Memo

Date	July 10, 2017
Project	Portland Building LU 17-153413 HRMAD
Project No.	74-16113-00
Subject	Rebuttal to Additional Testimony Submitted by July 3, 2017

Attachment A - Photos of metal screen facade discussed in response item 1.a

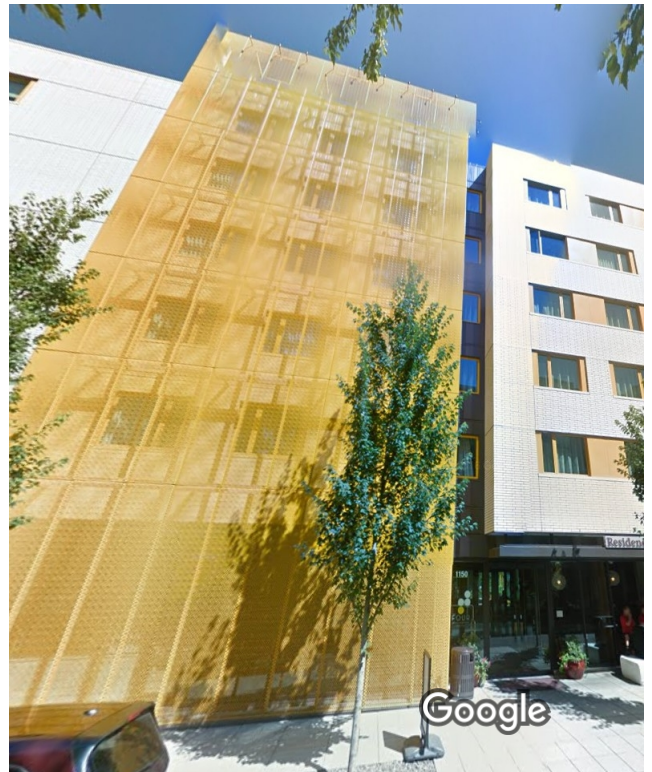
1. The first document that we are responding to was submitted by Peter Meijer Architect (PMA) and consists of a one-page cover letter with five attachments. It was uploaded to the City Auditor's E-files site and is titled "LU 17-153413 HRMAD 7-170703-PMA-HLC-Packet.PDF"
 - a. The document states that "Mr. Graves specifically comments on metal screen facades as 'monstrous' " and includes an October 09, 2014 Portland Tribune article for which Michael Graves was interviewed.
 - i. *Response: The building referred to in the quote is actually a masonry facade building with a small area of perforated metal screen wall that extends in front of several windows (see attached photo). Following is the Graves' quote with additional context taken from the article:*

He intensely dislikes the yellow, perforated metal screen wall on the front of the hotel he's staying in. "You can't see in and you can't see out. What's it for? I see it in magazines every day, they don't make facades anymore, they make screen walls. It's monstrous. It's a fad."

The current proposal for the Portland Building exterior cladding does not include perforated screens that run in front of windows as in the example cited.
 - b. The document provides a page titled "Two Independent Third Party Cost Estimates".
 - i. *Response: The limited information provided is insufficient to review or to respond to. There is no reference to the source of the estimates or to the information they were based on. The variation between the two quantities and prices provided by PMA (134,000 sf of exterior enclosure at \$5.7 million and 158,000 sf at \$80/sf or \$12.6 million) would indicate that there was not sufficient information to achieve any level of accuracy.*

Attachment B - Daylighting studies discussed in response item 1.c

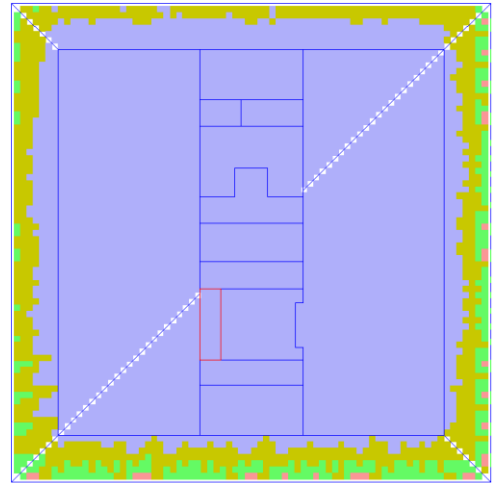
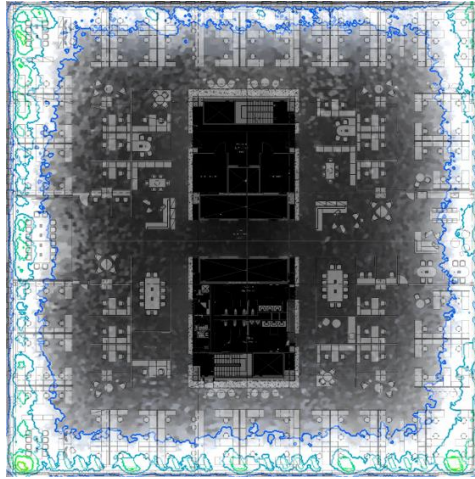
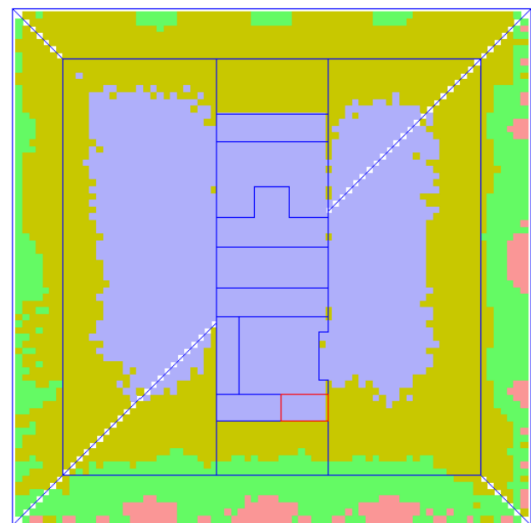
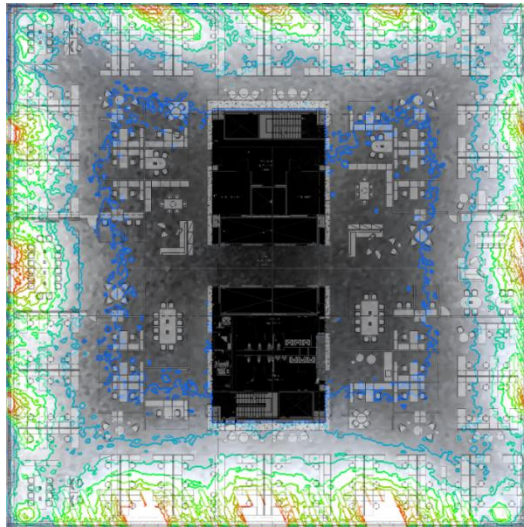
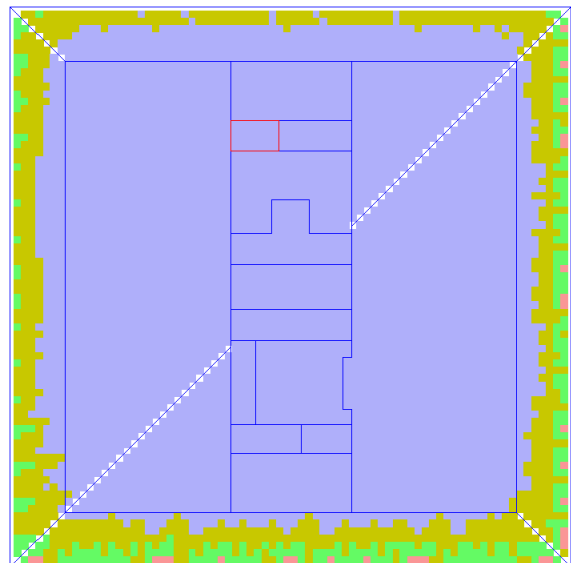
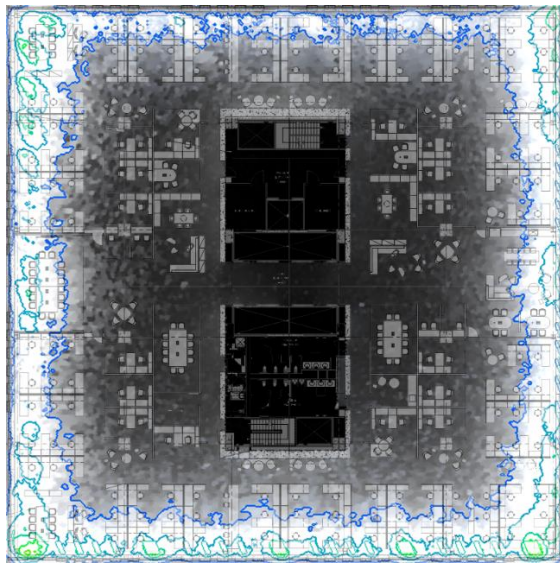
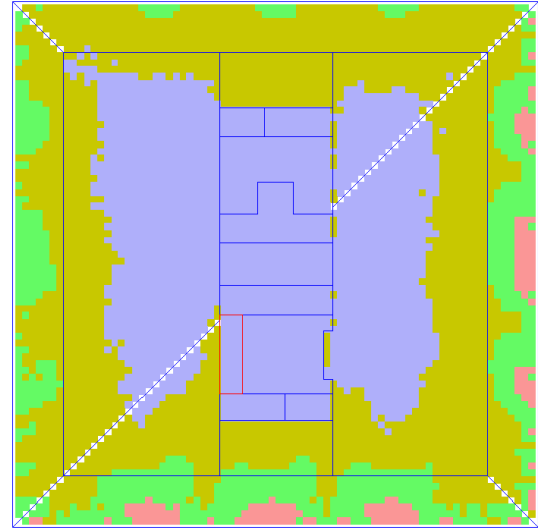
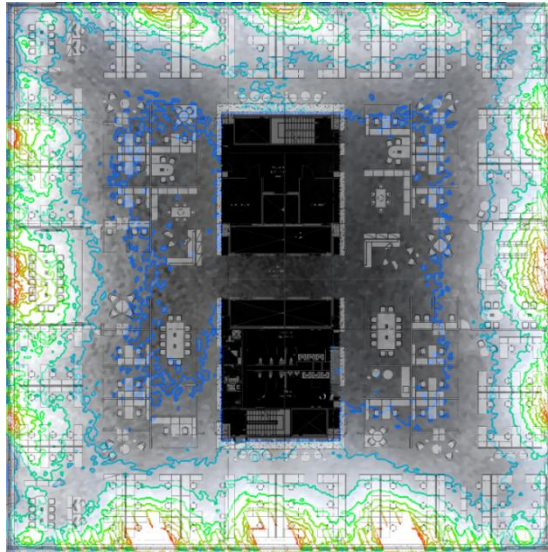
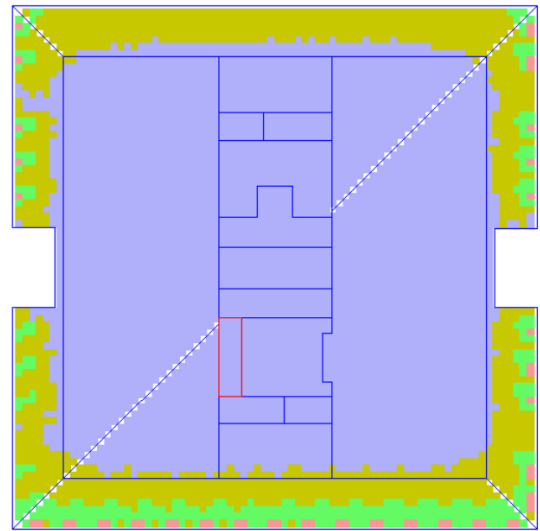
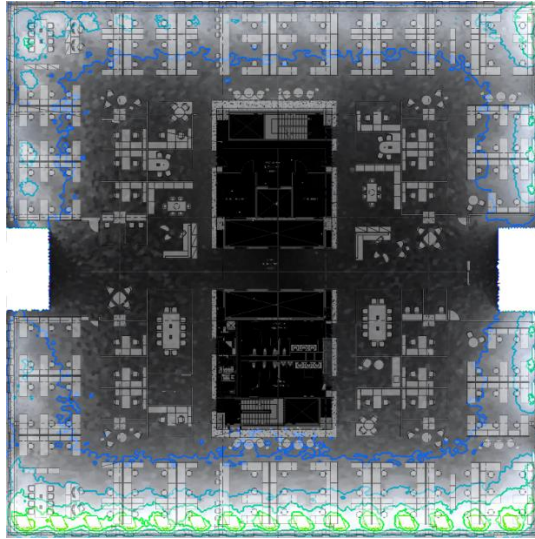
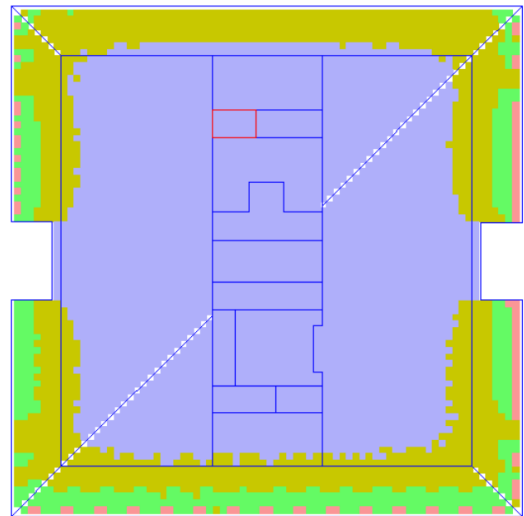
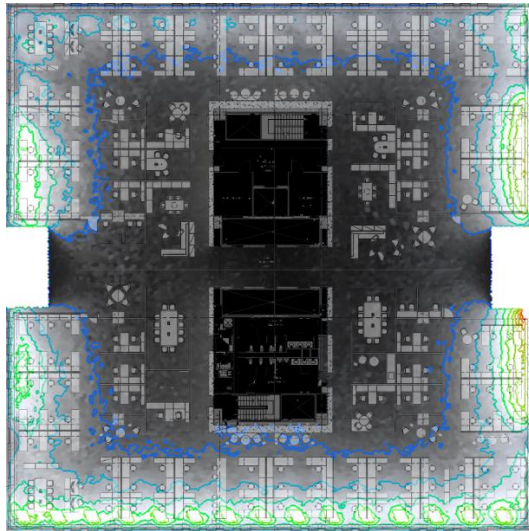
- c. The document claims that daylighting will be reduced by the depth of the system and provides a diagram implying a reduction in daylight.
 - i. *Response: The applicant is not able to comment on the diagrams provided by PMA since we have no knowledge of the assumptions they are based on.*

The Portland Building design-build team has done extensive daylighting studies to ensure that access to daylight will be increased by the proposed improvements to the exterior facade. Attached is a summary of the daylighting analyses that were produced in April of this year as part of our whole building energy analysis. The attached daylighting analyses show a significant increase in natural light for building occupants.

On an average the daylighting in the space is improved from 4% daylit with the existing floor plan to 20% daylit for the proposed floor plan.
